**A New Facilities Services Maintenance Building for:
Midwestern State University
Wichita Falls, Texas**

BYSP PROJECT NO. 18002

January 17, 2019

1 GROUND FLOOR MECHANICAL PLAN
1/8" = 1'-0"

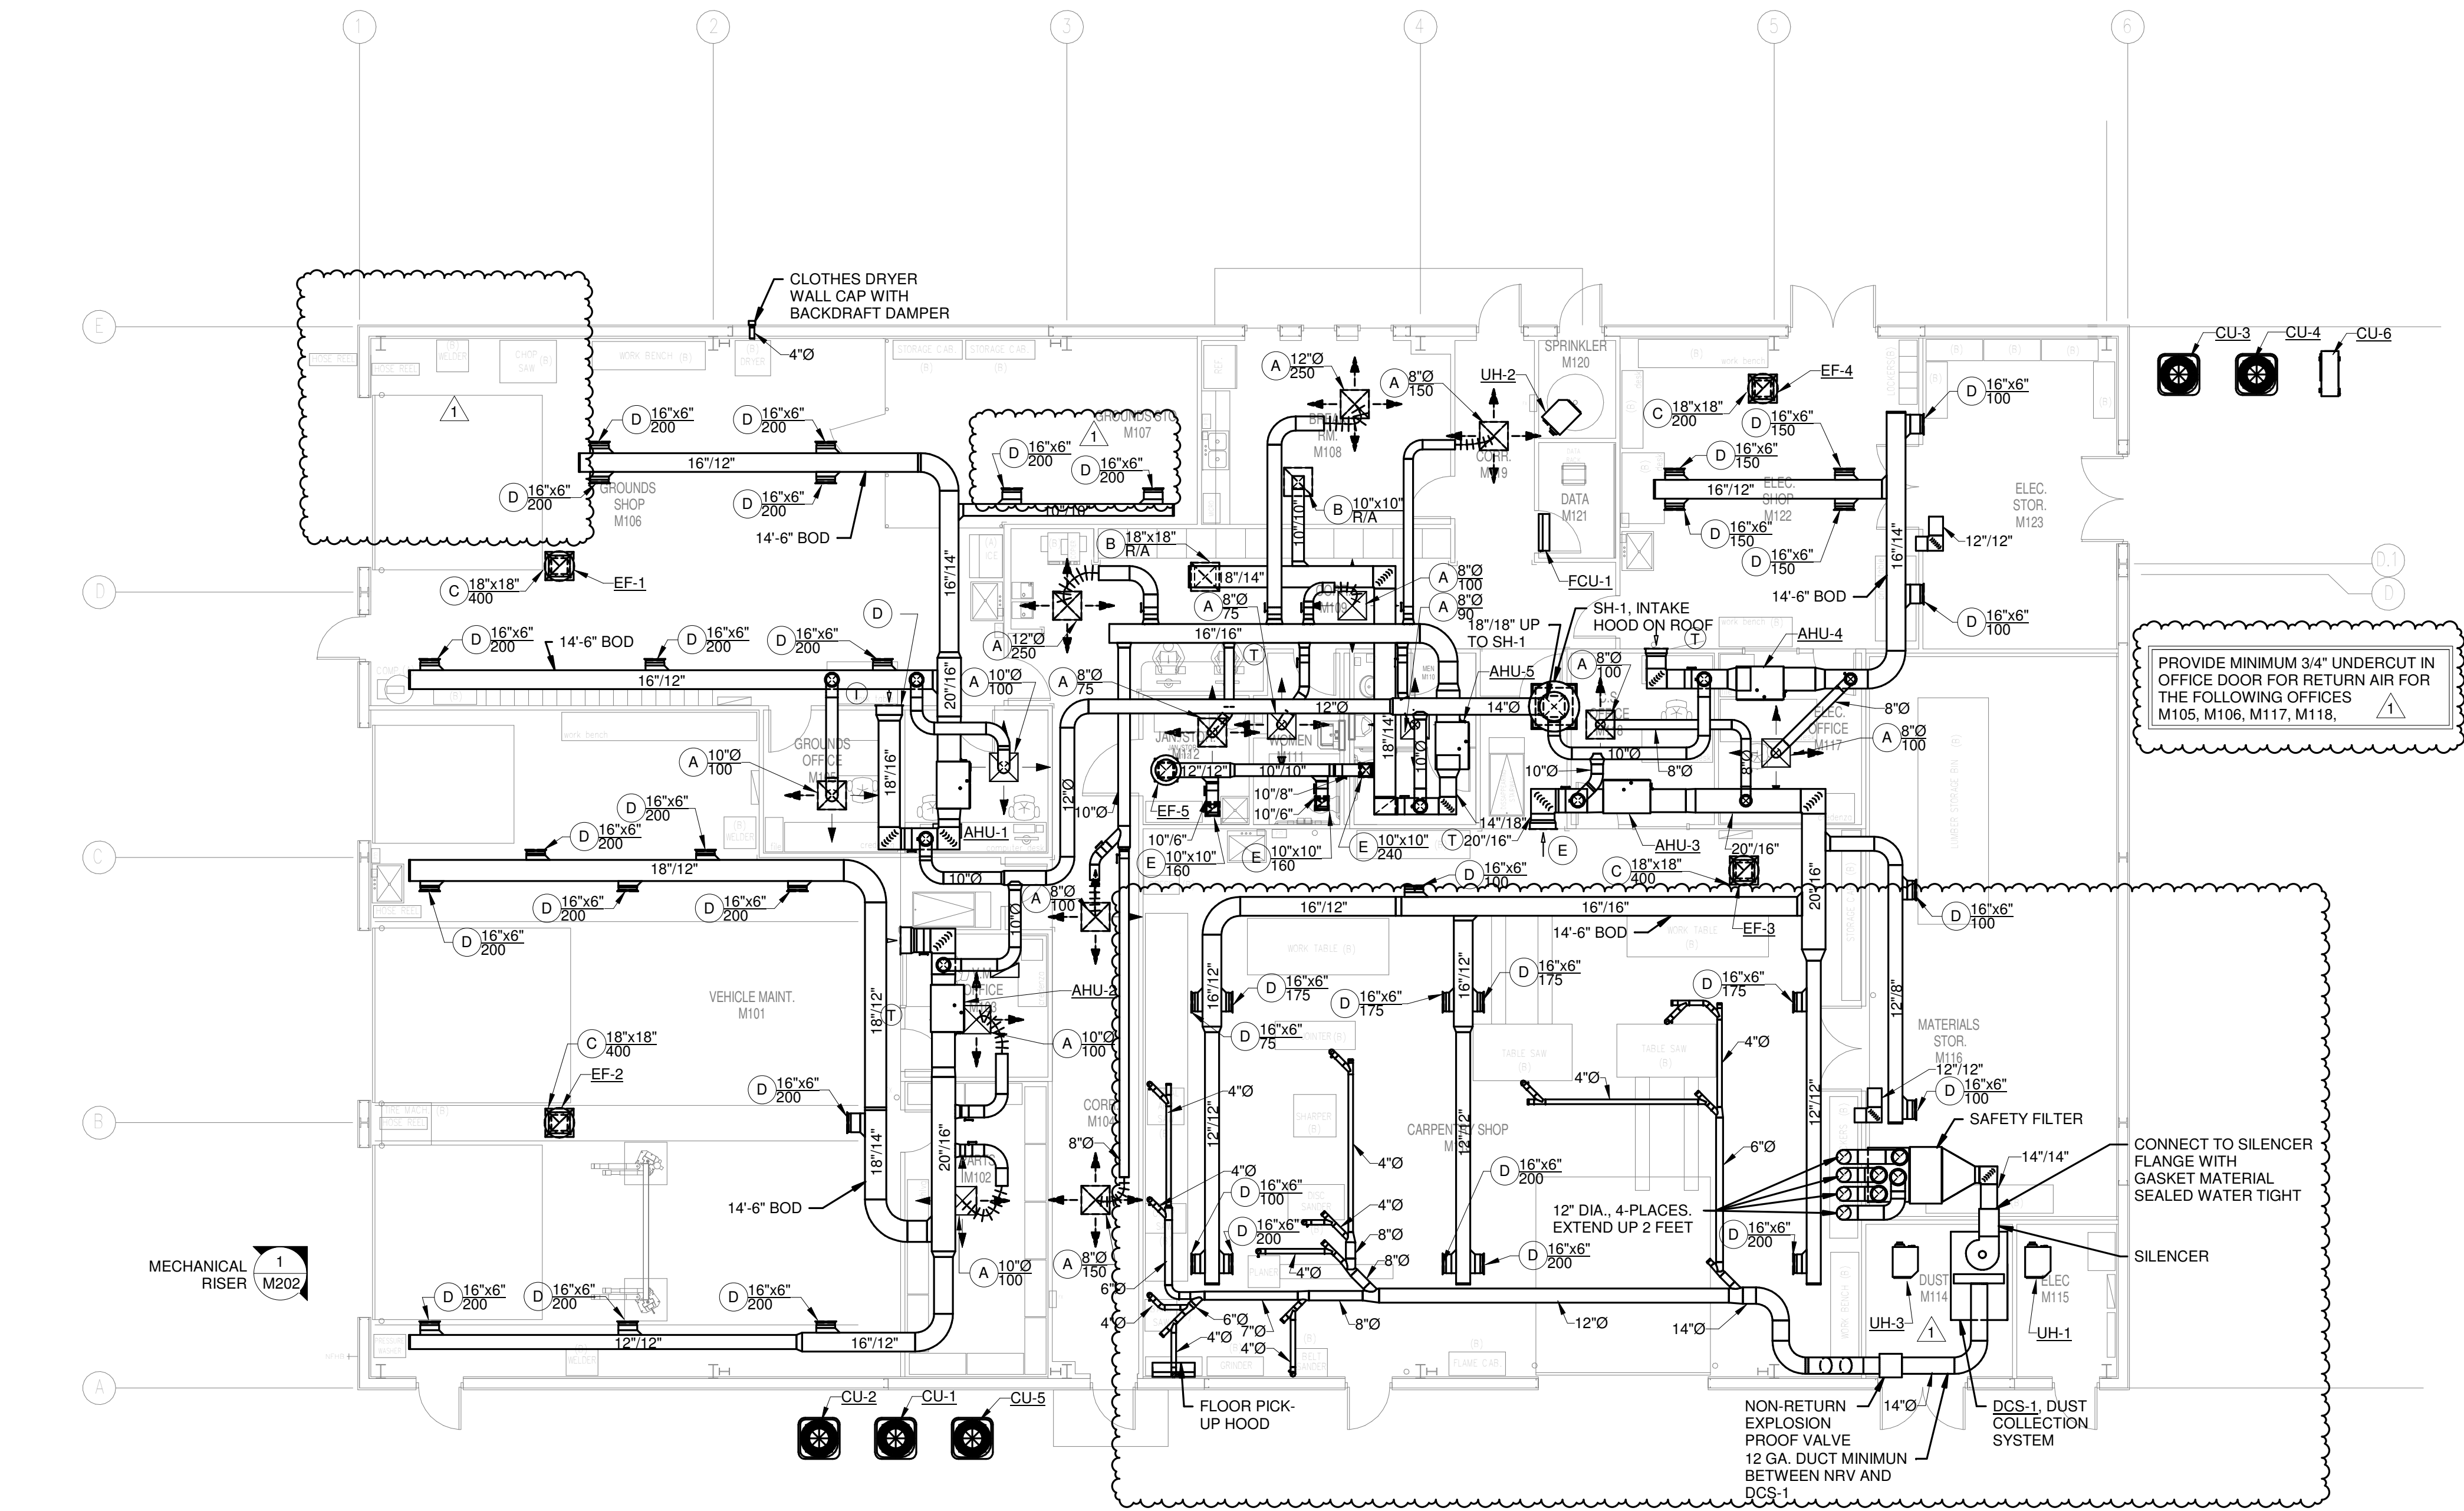
Sheet M201: Ground Floor Mechanical Plan

Replace drawing M201 issued 12/11/2018 with the attached drawing M201.

Changes include:

1. Removal of relocated welding hood and associated ductwork and exhaust fan in Grounds M106.
2. Modifications to air flows in Grounds Storage M107
3. Duct size changes for dust collection system in Carpentry.
4. Re-arrange, modify Dust Collector orientation and ductwork requirements
5. Note added for doors in offices below Equipment Platforms to have the door undercut for return air.

M201

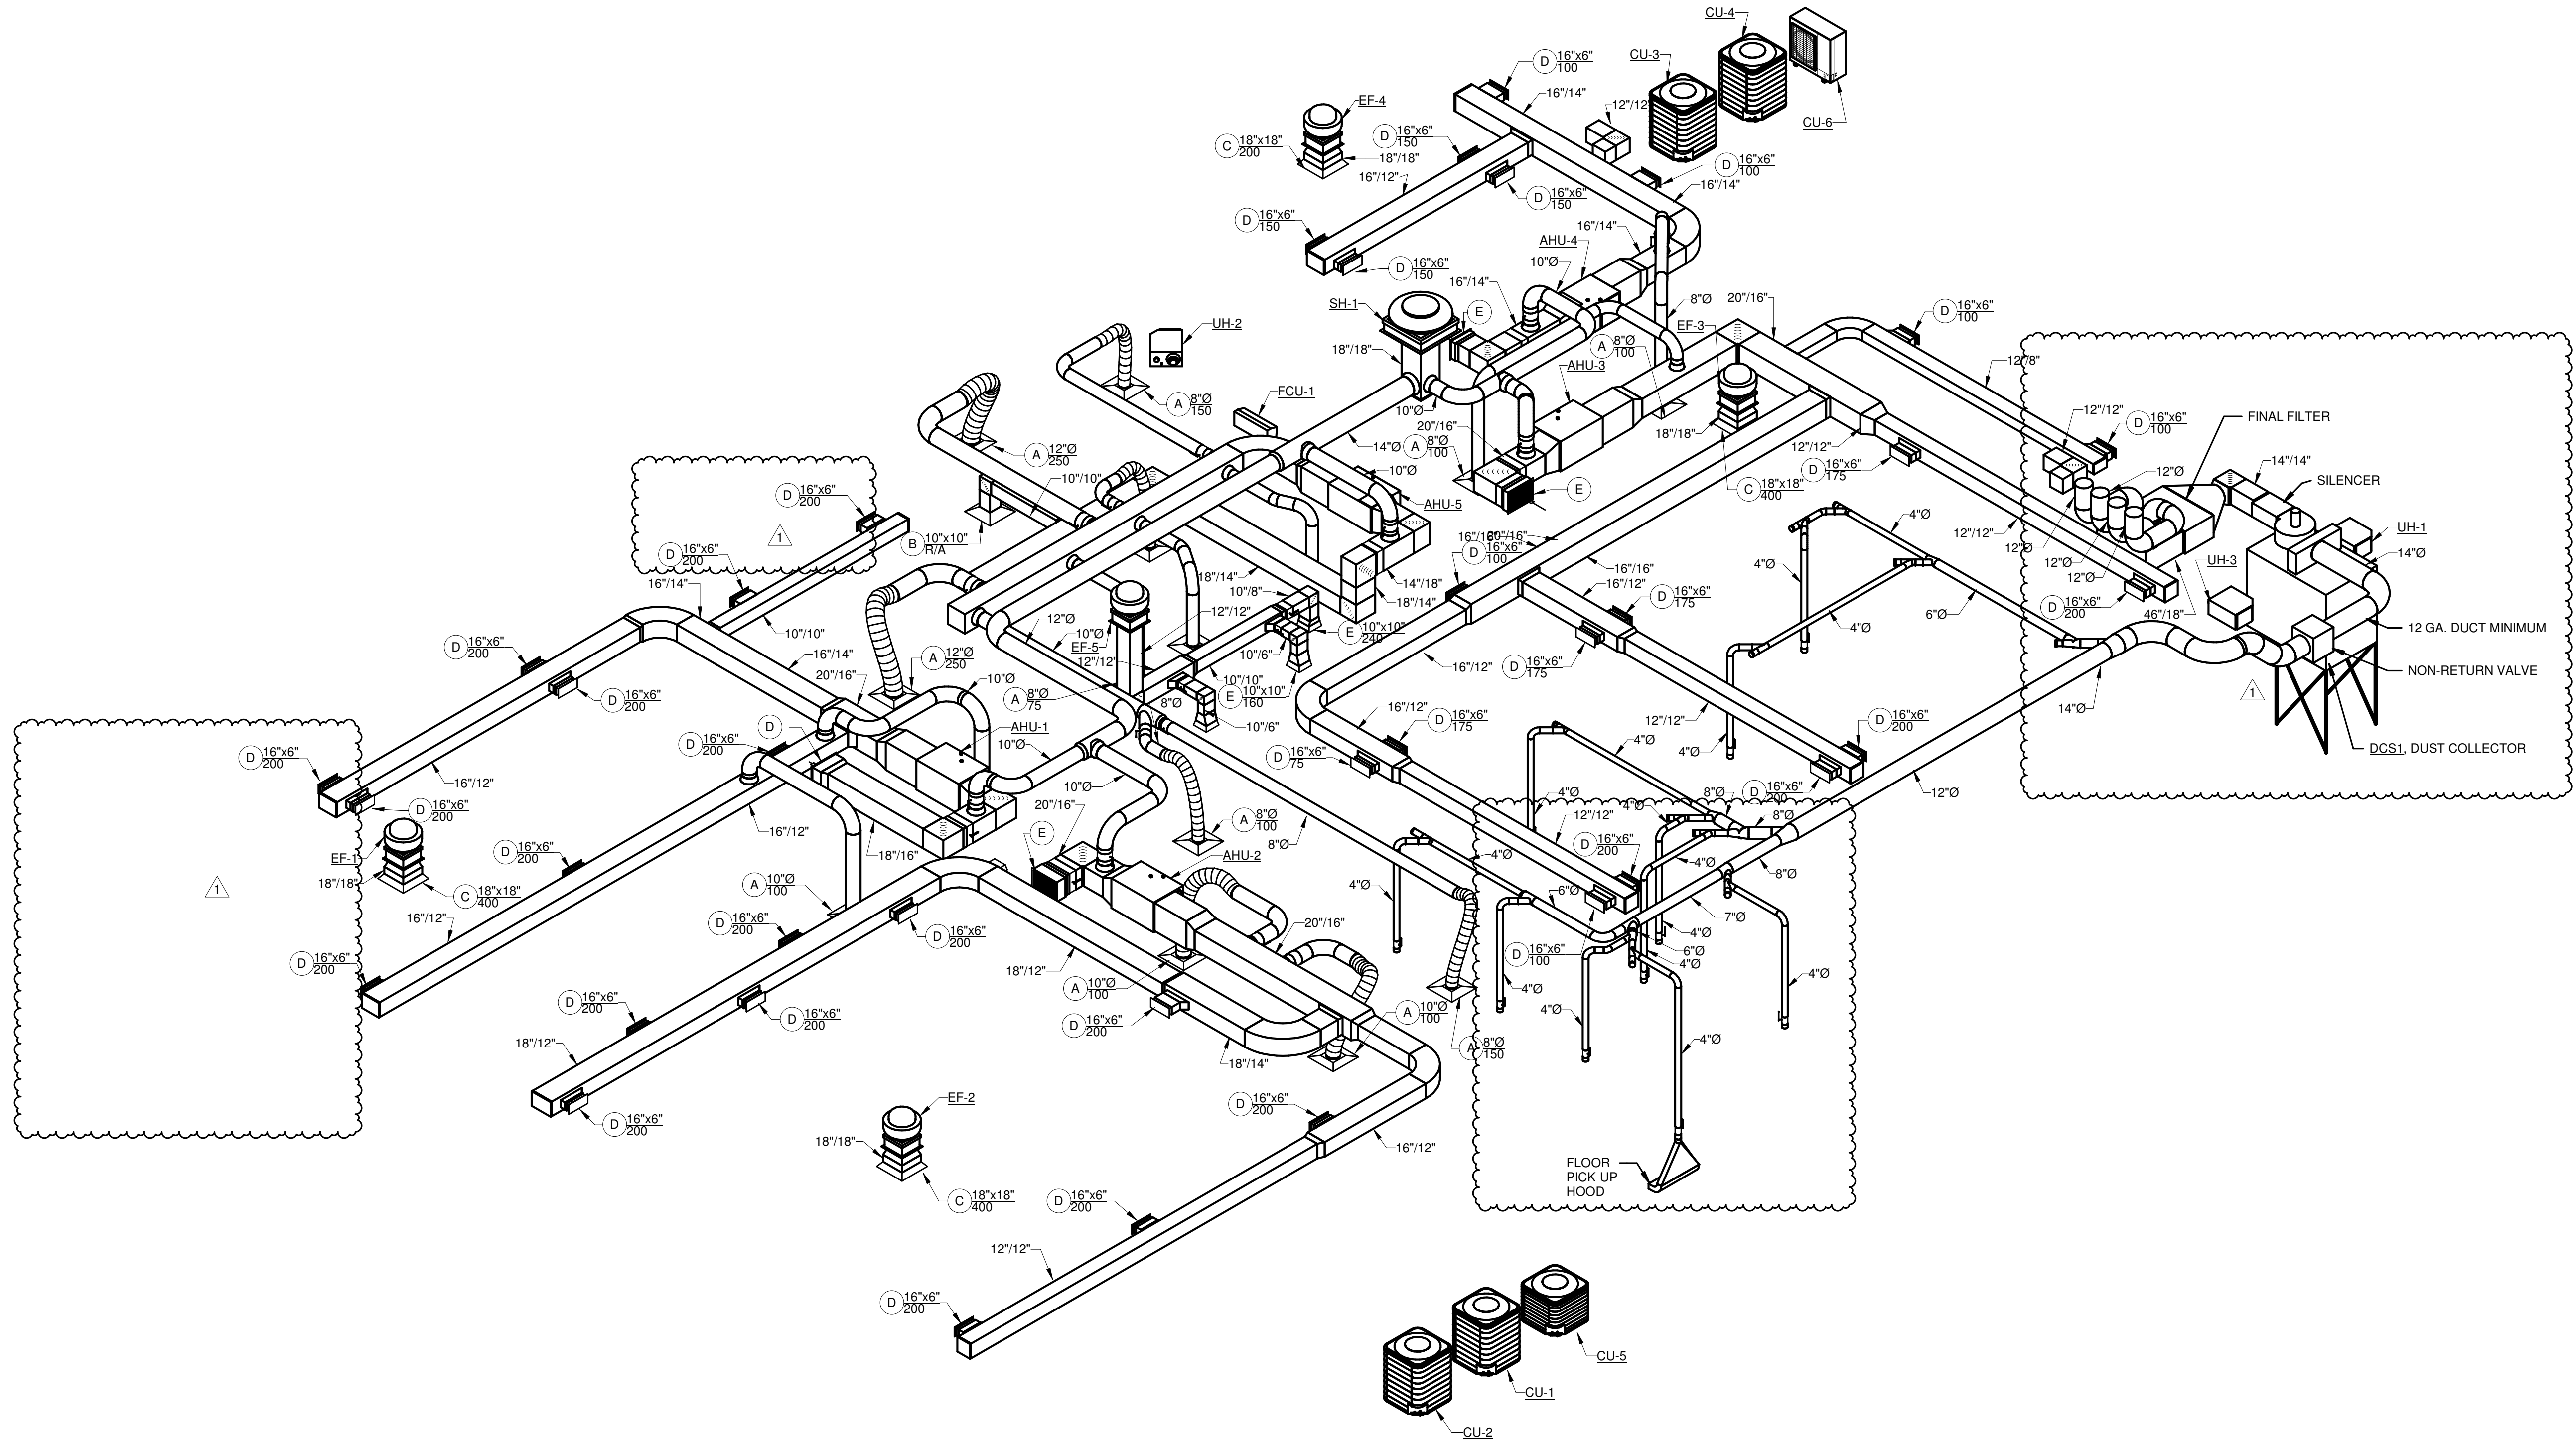
Sheet M202: Mechanical Isometric

Replace drawing M202 issued 12/11/2018 with the attached drawing M202. Changes reflected on drawing M201 duplicated in riser.
